Addendum #2

Project Name: Concordia STEM
Seward, NE
Project No.: 16022-05
Date Issued: May 8, 2018
Bid Date: Thursday, May 17, 2018

1 Lower Level Plumbing Waste & Vent – Area B.2
1/4" = 1'-0"

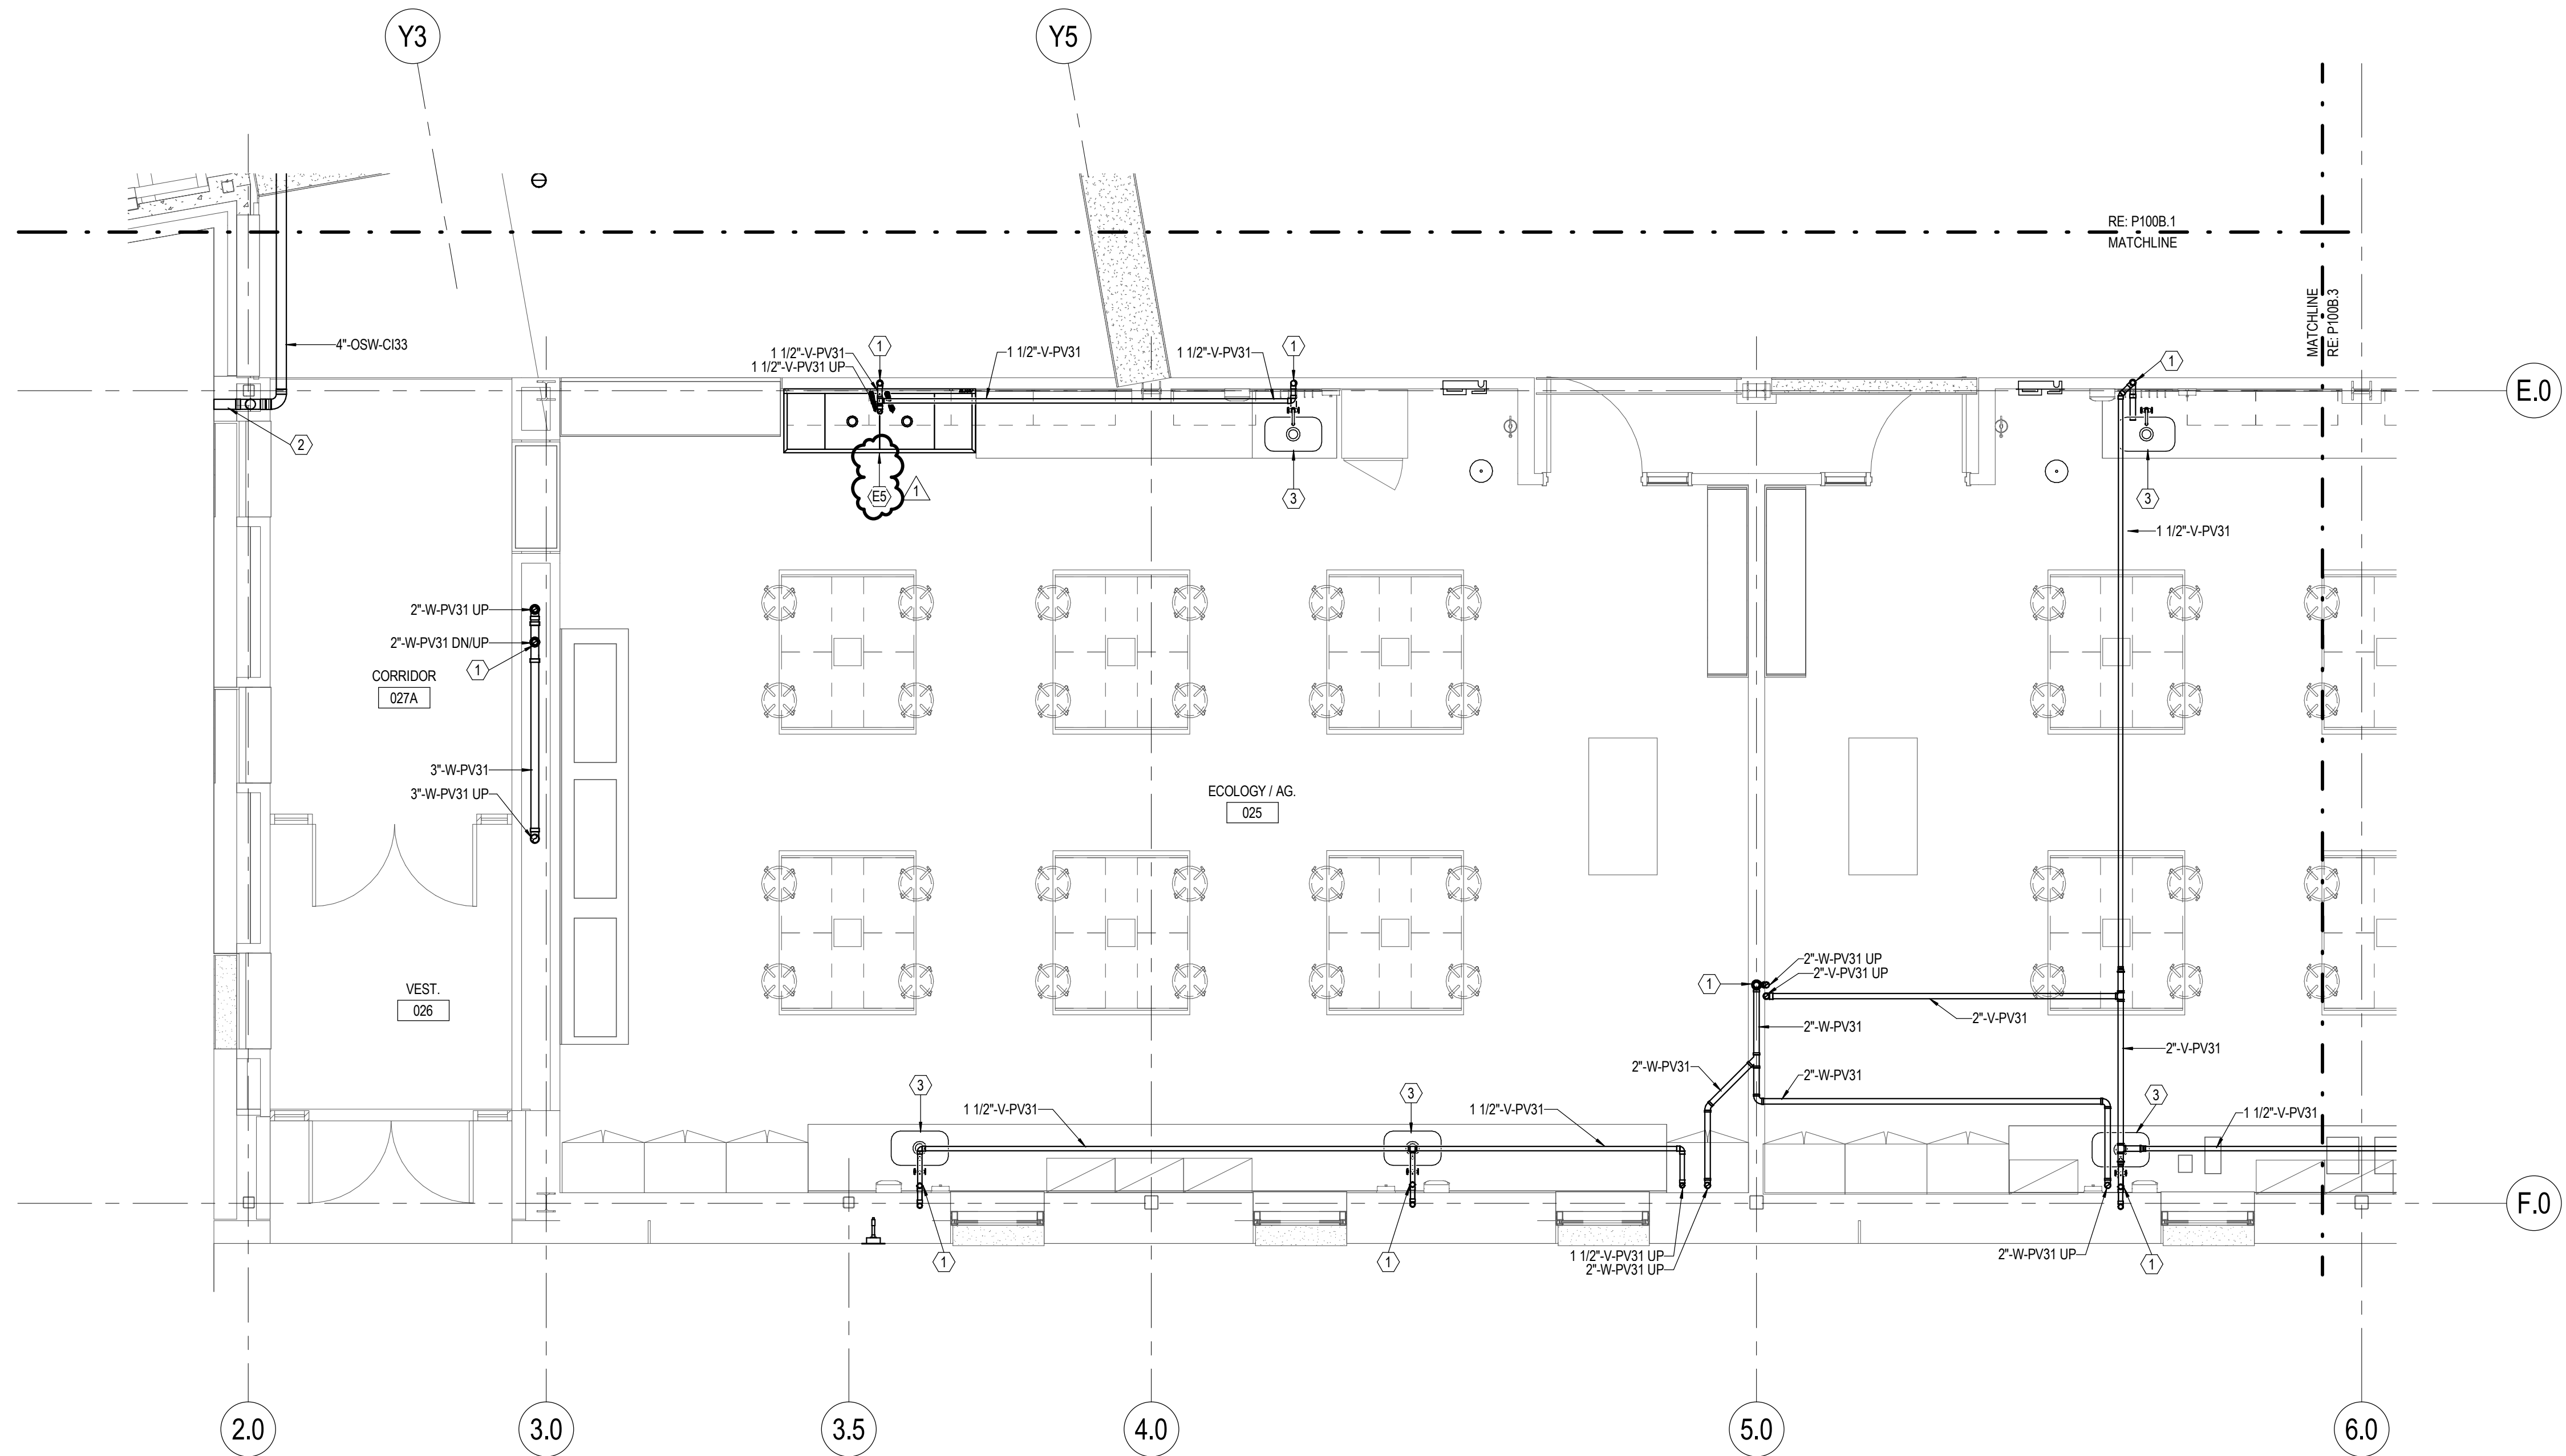
ADD 2-22. Drawing P100B.2. Add fixture E5 tag for sink in the Ecology / AG. room.

P200B.2

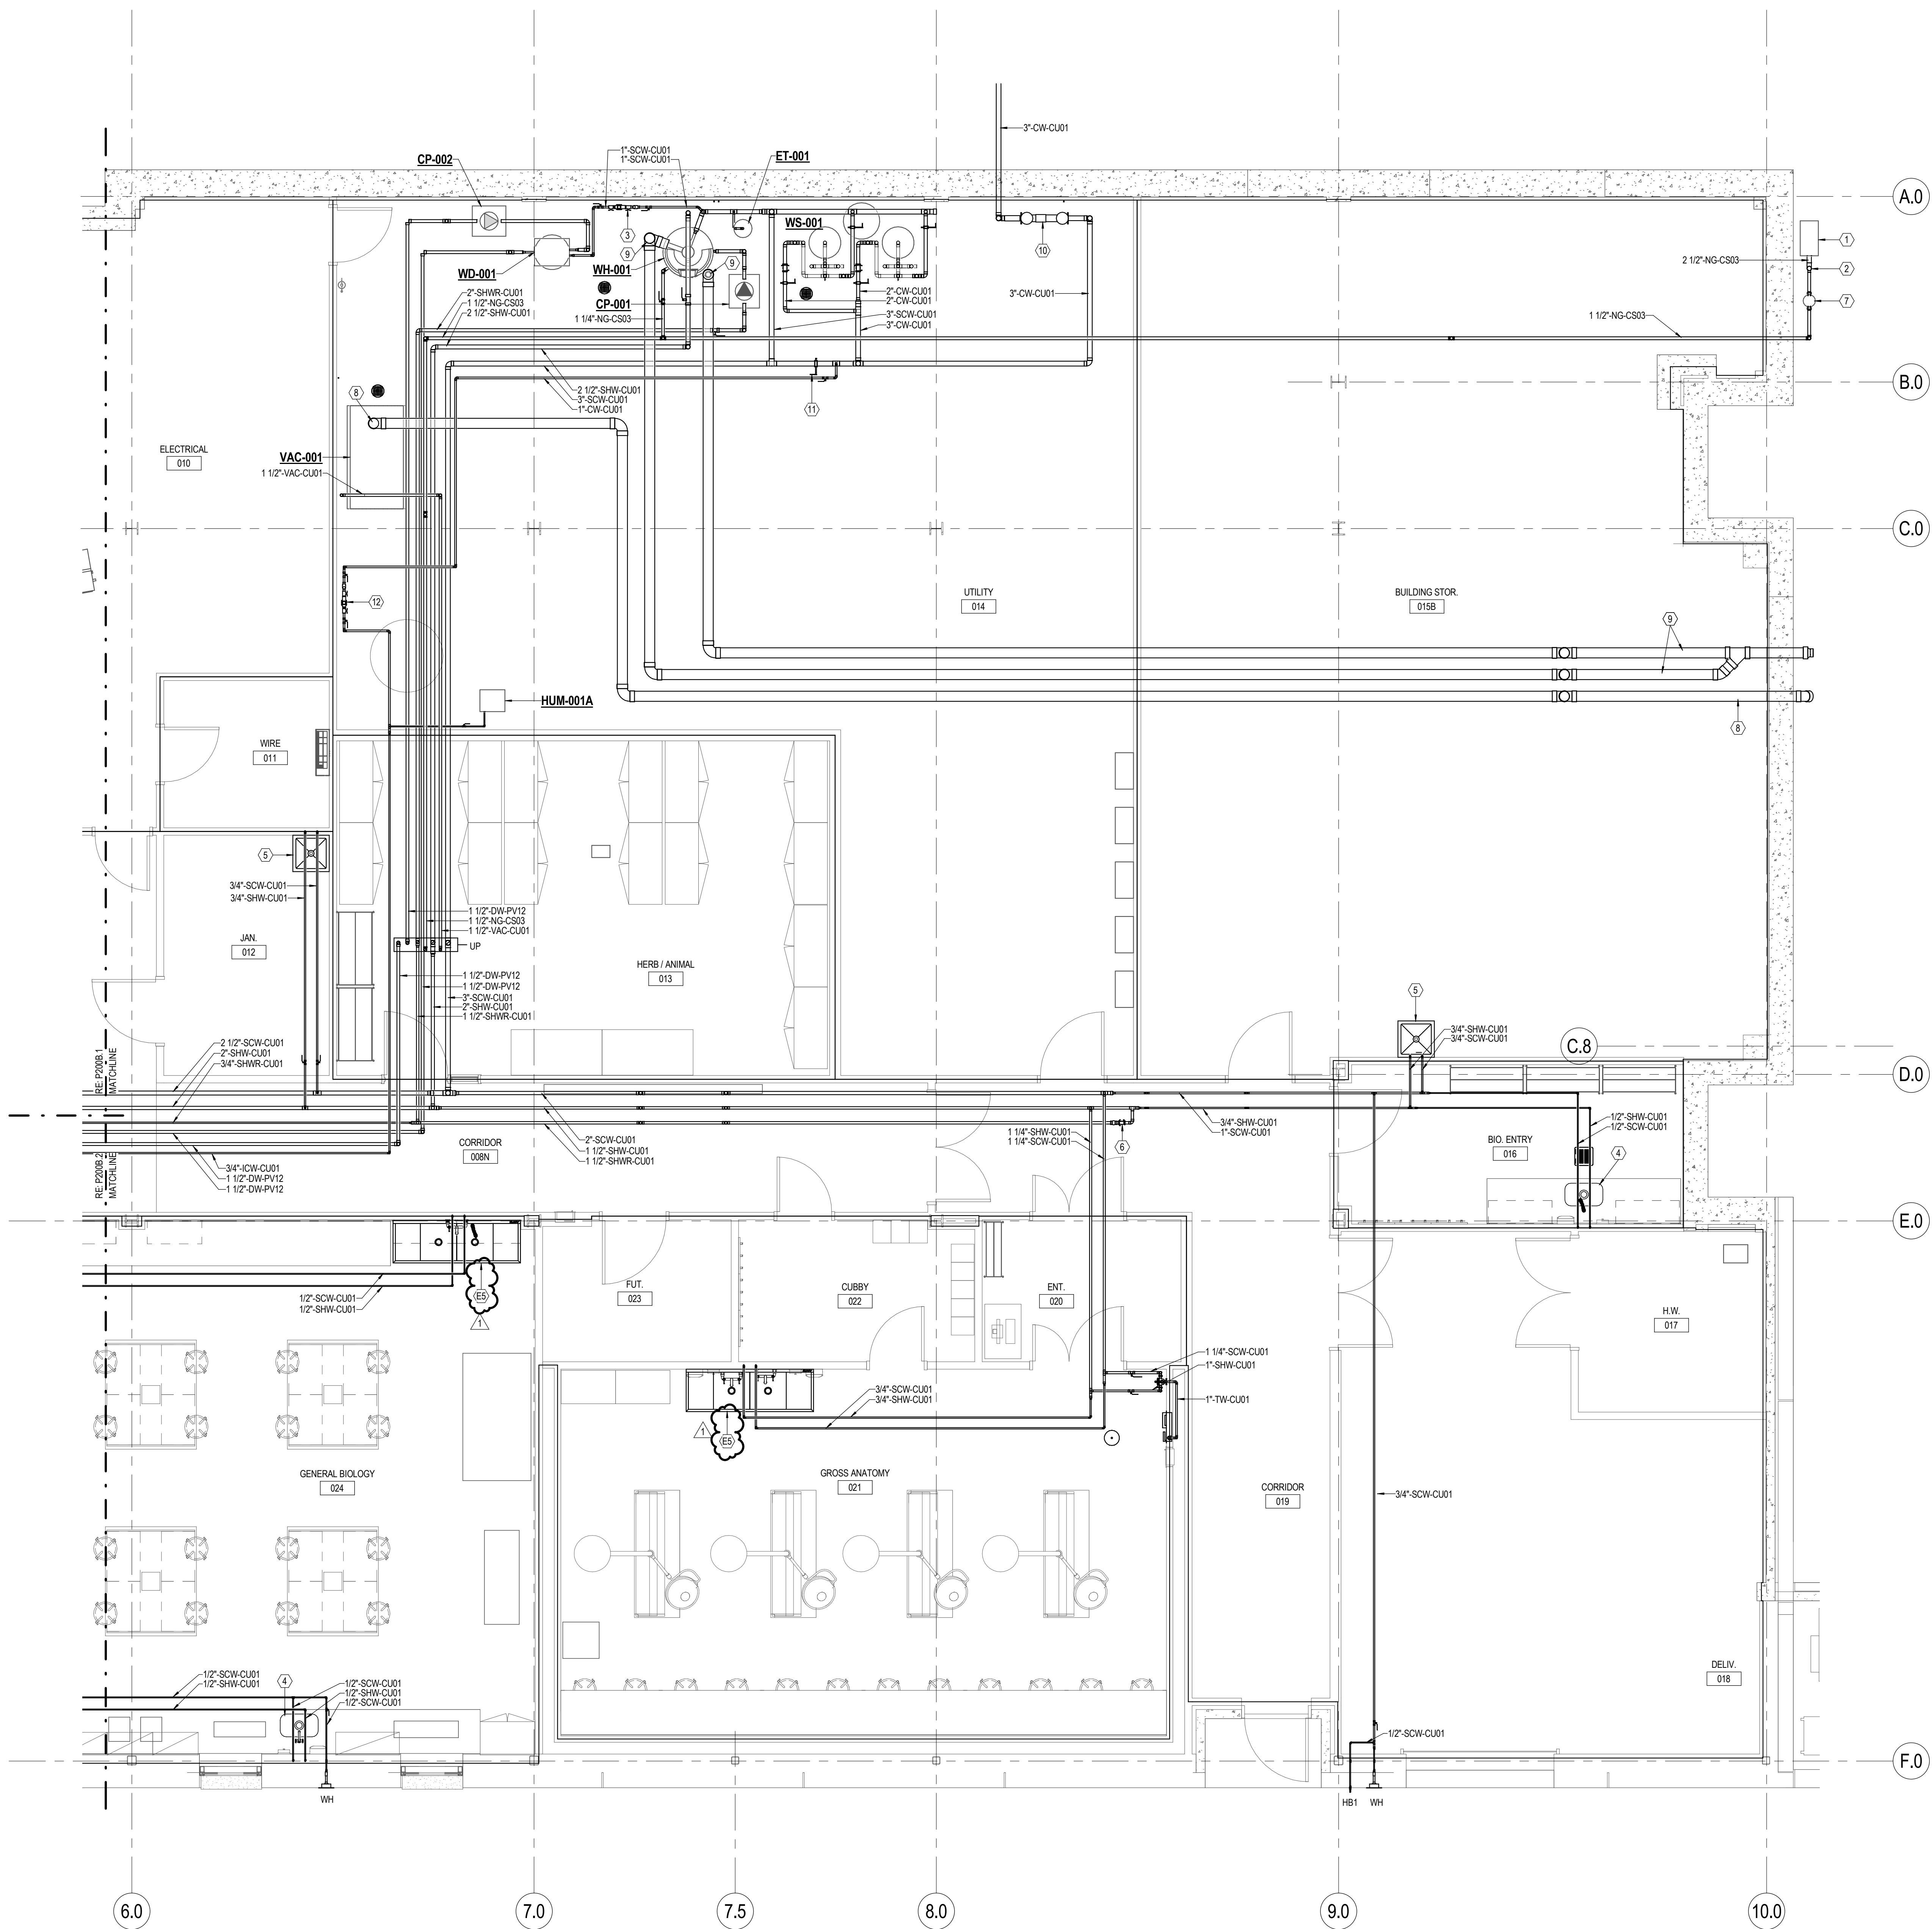
ADD 2-24. Drawing P200B.2. Add fixture E5 tag for sink in the Ecology / AG. room.
